SHERWOOD PROJECT

**RE: Radioactive Materials License WN-I0133-1; License Condition No. 29:
Request for Termination of License WN-I0133-1 Issued for the Sherwood
Project Operated by Western Nuclear, Inc.**

**REQUEST FOR LICENSE TERMINATION
FINAL DATA SUBMITTAL**

FIGURE 1

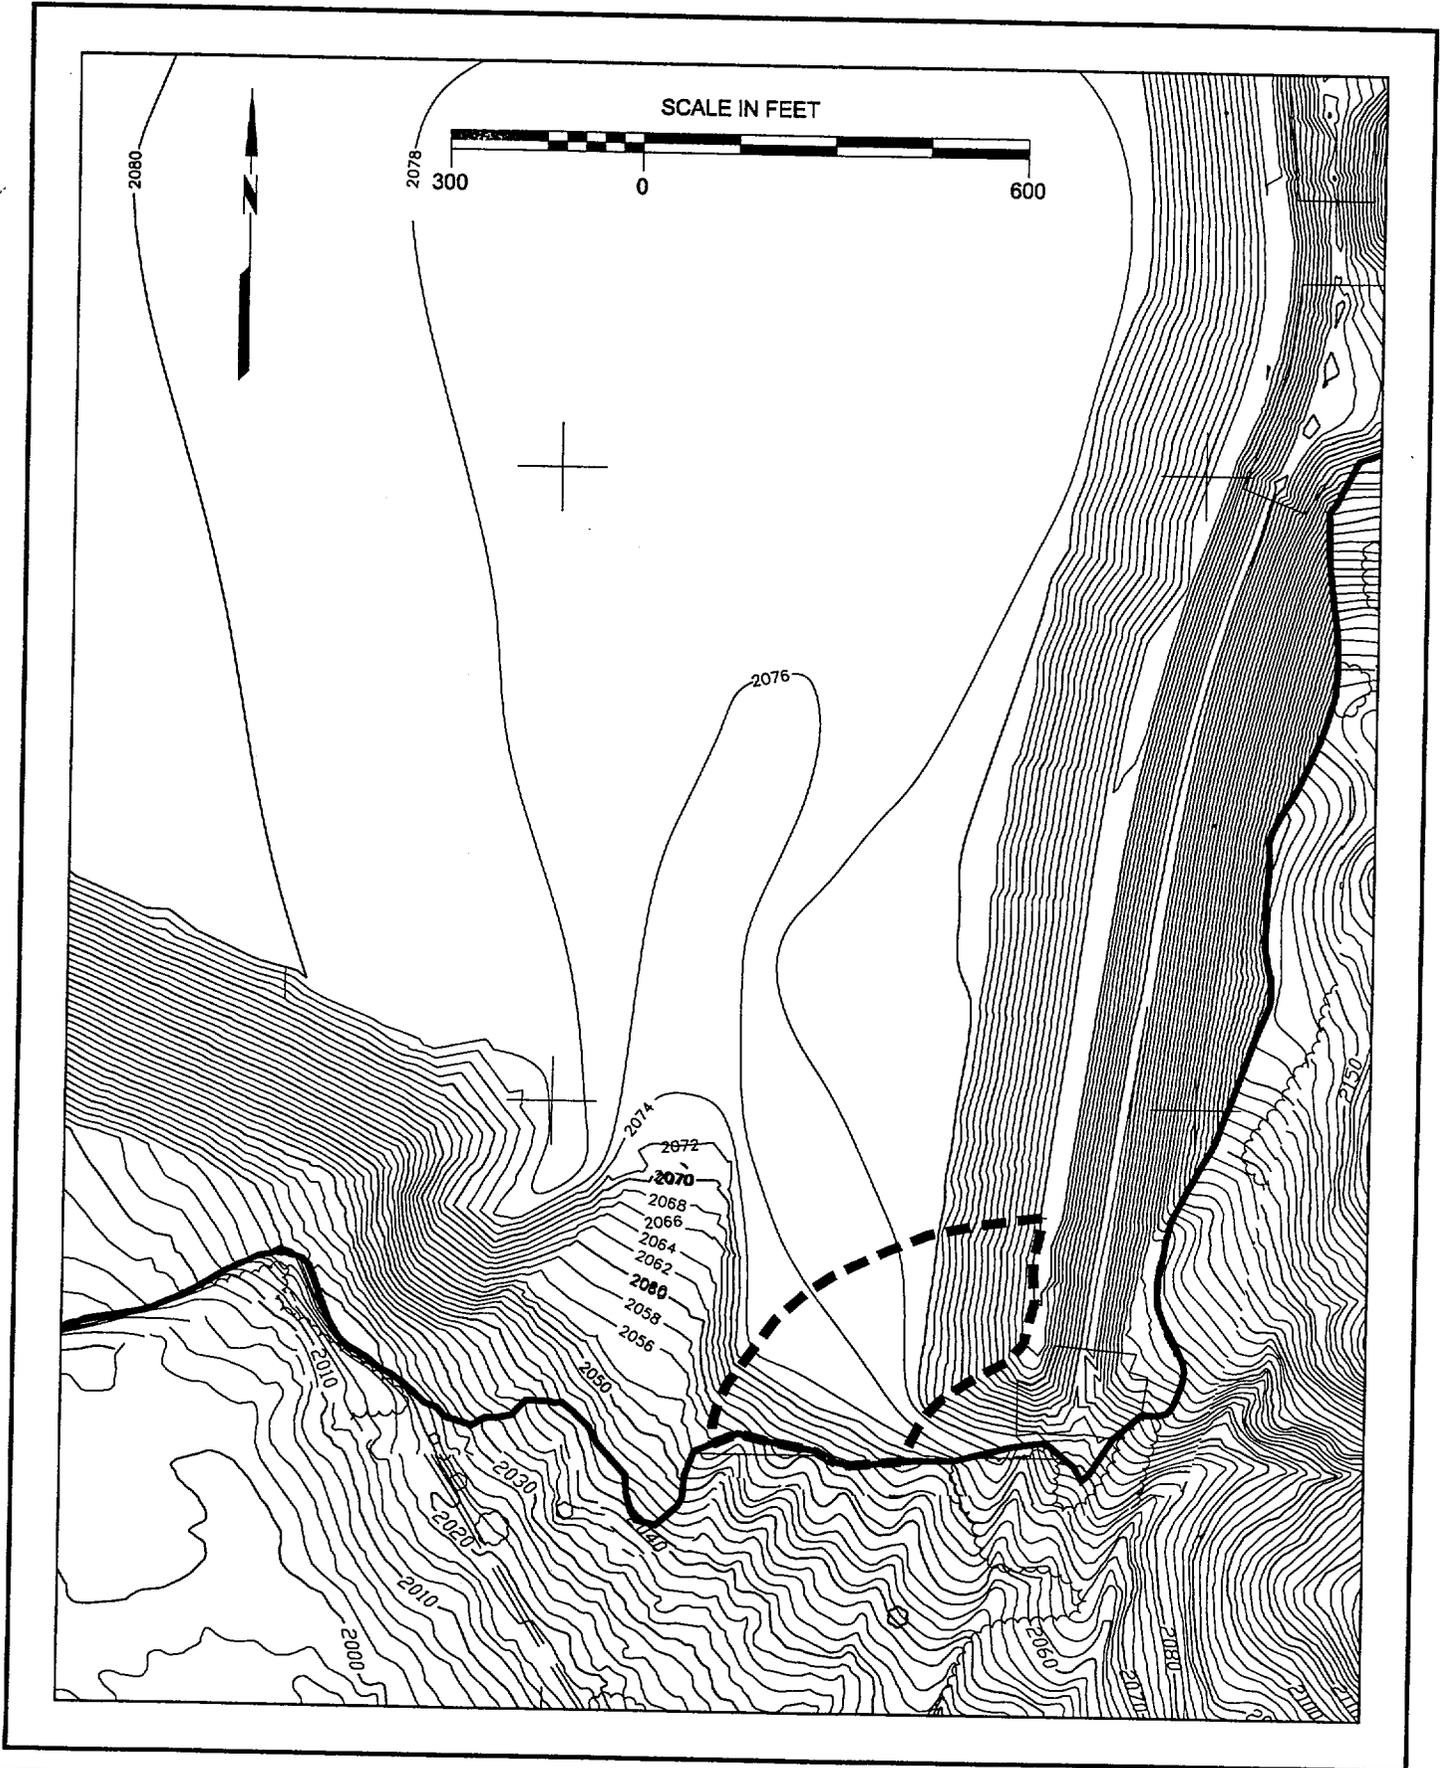
RESPONSE

There is a small area (approximately 3 acres) between the swale outlet and the margin, as shown on Figure 1, that drains to the south. This drainage configuration is consistent with the original design. As the regraded gentle slope transitions into the steeper natural topography, a small amount of gullying and general erosion is apparent. This erosion will not, however, impact the reclaimed tailing impoundment. Any head-cutting would be limited to the small drainage basin, which is at least 700 feet from the edge of the reclaimed tailing surface. Additionally, quartz monzonite bedrock is at or near the surface for much if not all of this small drainage basin and therefore any gullying would be limited to a depth of only a few inches.

FIGURE 1
TYPICAL CROSS SECTION

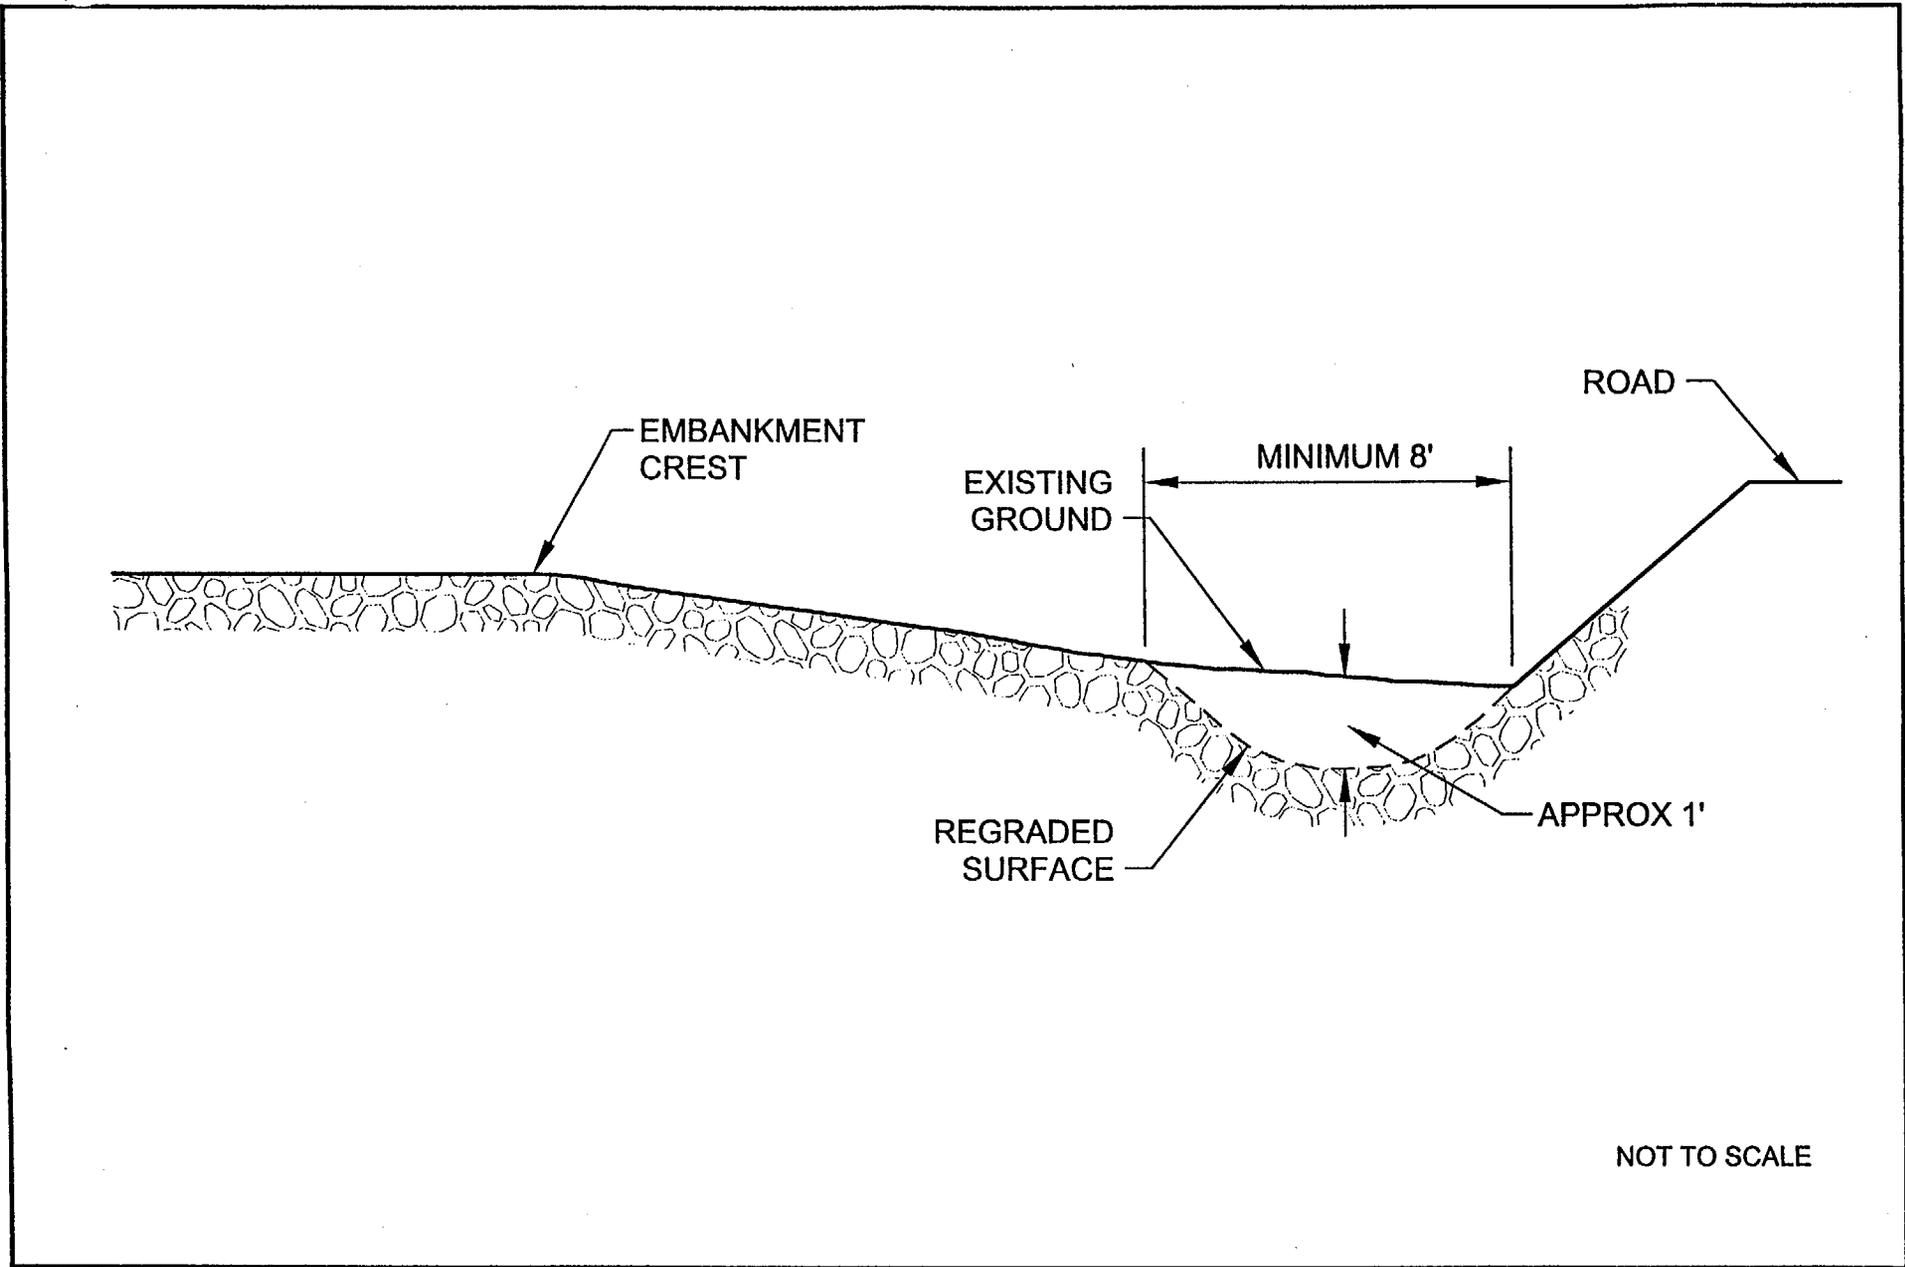
This letter is in response to your letter dated September 21, 1999 regarding surface stability inspection issues at the Sherwood project site. Specifically this letter presents the required design to address the regrading activities for Issue 1, the area immediately west of the reclaimed embankment and Issue 3, the reclaimed northwest borrow area.

As discussed during our site inspection on September 7, 1999 this concern will be addressed by enlarging the existing drainage to the south to keep drainage water away from the groin area. This will be done by removing the existing rock in the drainage, excavating the subsoil material and replacing the existing rock. Figure 1 depicts a typical cross section of the reconfigured drainage.

FIGURE 5.1
DIVERSION CHANNEL
SCHEMATIC

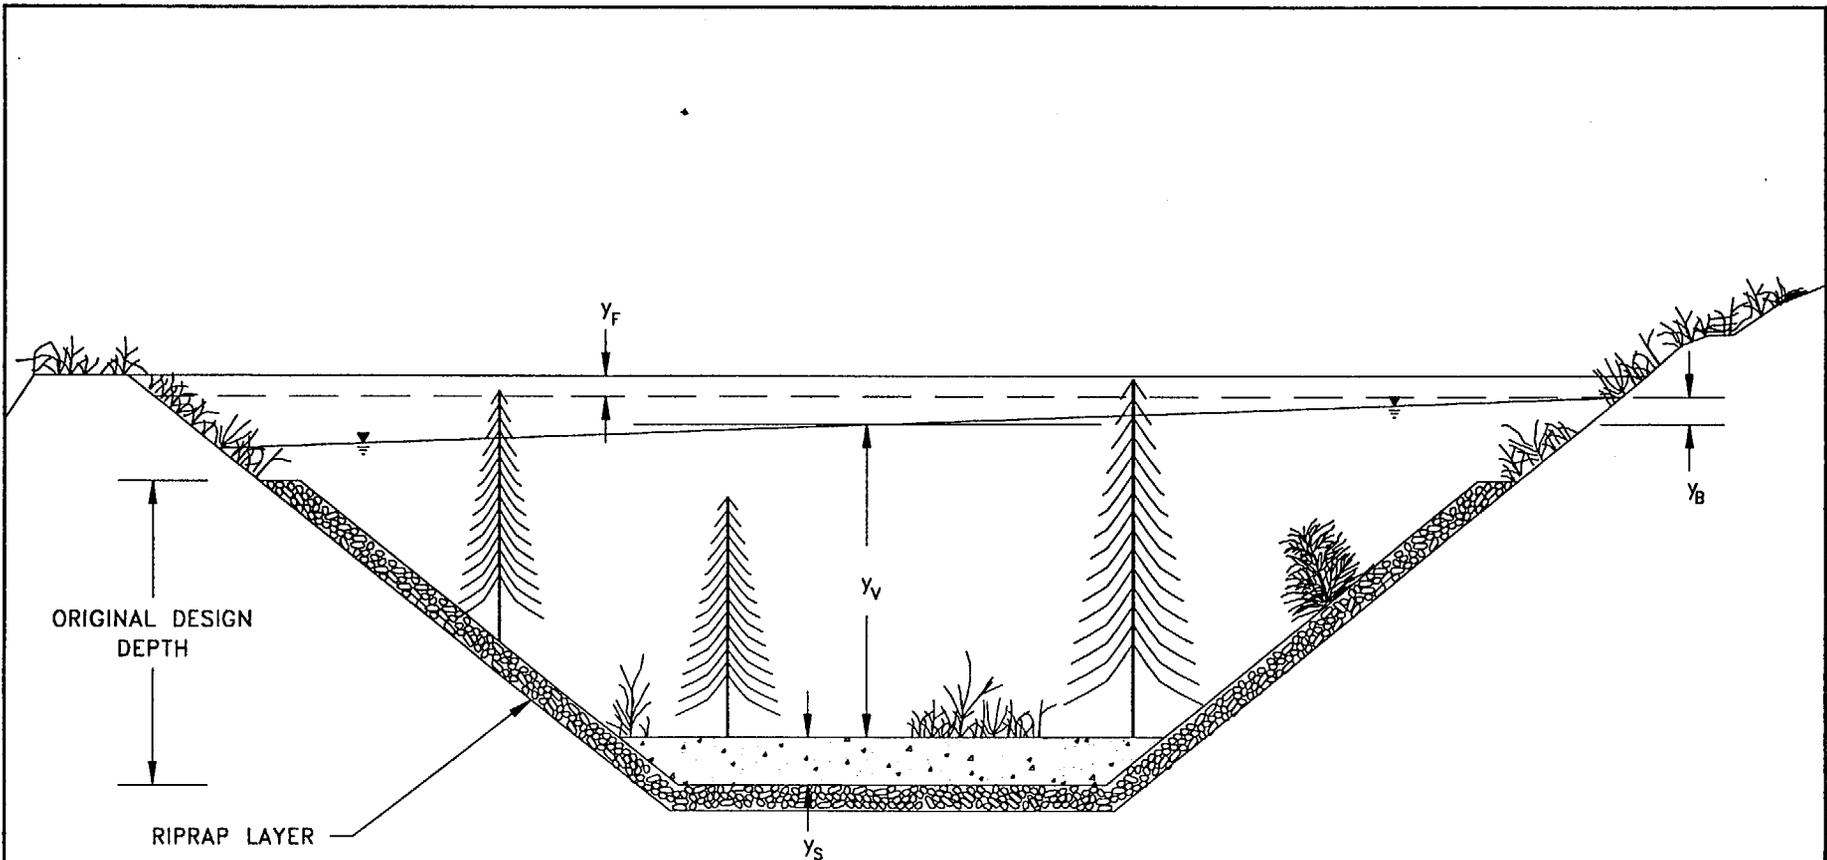
5.0 DIVERSION CHANNEL DESIGN MODIFICATION

Since relocation or deletion of the diversion channel are not beneficial alternatives, modification to the diversion channel design in the 12/94 TRP, is proposed to ensure that the channel will contain 1) 2.0 feet of sediment deposited on the bed, 2) PMF flows through a vegetated channel as modeled by HEC-2 with Manning's n equal to

0.10, 3) superelevation, and 4) 1.0 foot of freeboard. The 1.0 foot of freeboard in addition to considerations for sediment, vegetation, and superelevation, is a final degree of conservatism and provides significant cross sectional area to the channel should it be needed. For example, at the downstream end of the channel, the depth is 22 feet and the top width is 140 feet wide. The cross sectional area in the upper 1-foot of channel is about 137 square feet. This area corresponds to a depth of over 5.8 feet at the bottom of the channel. Therefore, there could be as much as 5.8 feet of sediment in the channel and the PMF would still be contained within the channel freeboard.

Figure 5.1 shows the modified channel design schematically. The design of the diversion channel is proposed to be modified by increasing the amount of compacted fill on the berm between the channel and the tailings impoundment. Table 5.1 summarizes the changes in design depth for the channel, comparing channel depth as presented in the 12/94 TRP to the modified channel depth designed for sediment, vegetation and superelevation. Table 5.2 is a more detailed summary of the issues investigated in this response report.

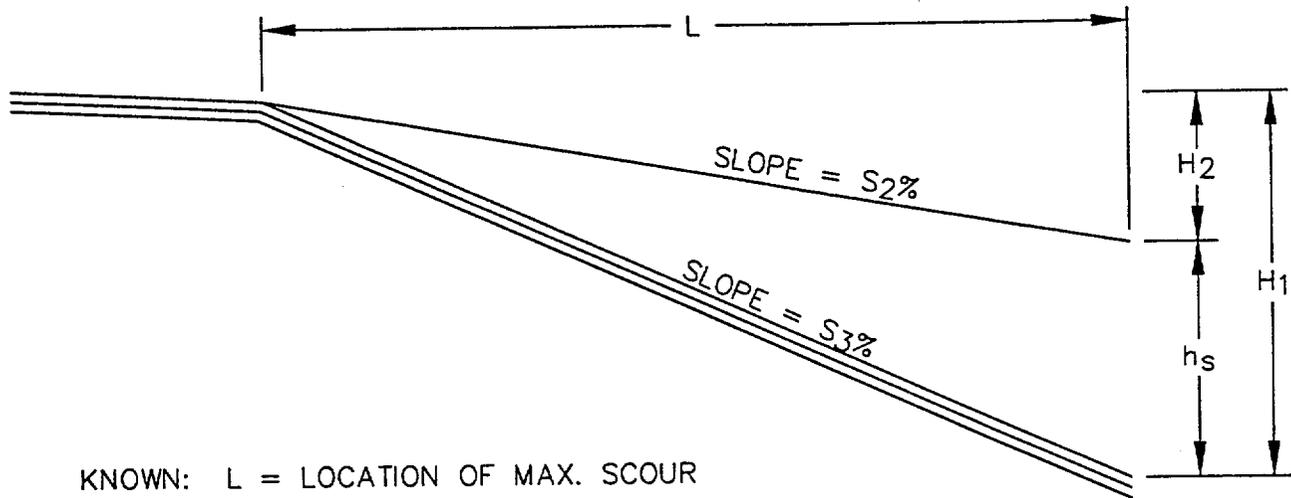
Drawing 7 of the WDOH approved Technical Specifications presents plan and profile views of the Tailing Cover Impoundment Swale Outlet. That drawing indicates that the buried apron of the outlet requires a slope of 15%, a scour depth of 4.5 ft and a length of 30 ft. A survey of the finished swale outlet structure has indicated dimensions that vary somewhat from the Drawing 7 dimensions.

As illustrated in Figure O-1, the slope of the tailing swale apron (S_3) is equal to the depth H_1 divided by the length L. However, since the value of H_1 is not known, it is necessary to derive an equation for S_3 in terms of the ground slope S_2 and the scour depth h_s , which are known values. The equation as derived on Figure O-1 is as follows:

The swale apron slope is shown in Drawing 7 of the November 1996 Technical Specifications as 15%. This value is in error because as stated in the footnote in Table O-1, an incorrect depth was used in the slope calculation. Using the equation above results in a correct slope of 21%.

FIGURE 1
TYPICAL CROSS SECTION

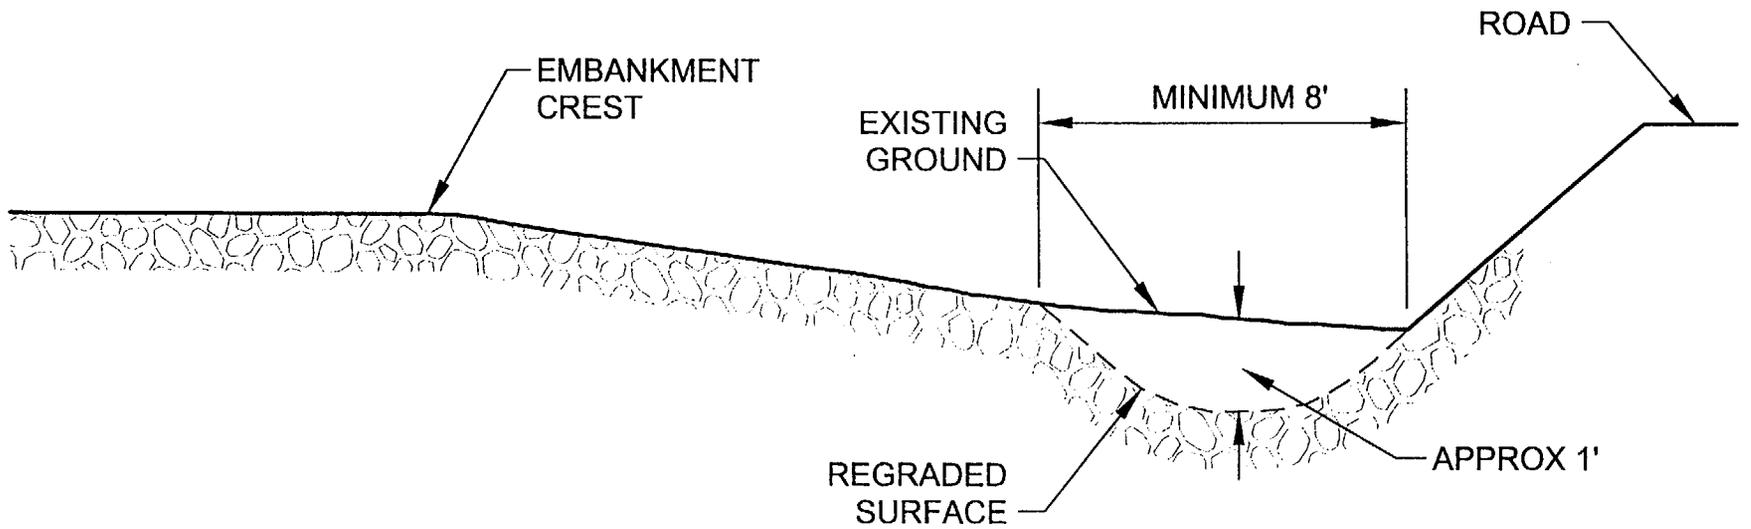
This letter is in response to your letter dated September 21, 1999 regarding surface stability inspection issues at the Sherwood project site. Specifically this letter presents the required design to address the regrading activities for Issue 1, the area immediately west of the reclaimed embankment and Issue 3, the reclaimed northwest borrow area.

As discussed during our site inspection on September 7, 1999 this concern will be addressed by enlarging the existing drainage to the south to keep drainage water away from the groin area. This will be done by removing the existing rock in the drainage, excavating the subsoil material and replacing the existing rock. Figure 1 depicts a typical cross section of the reconfigured drainage.
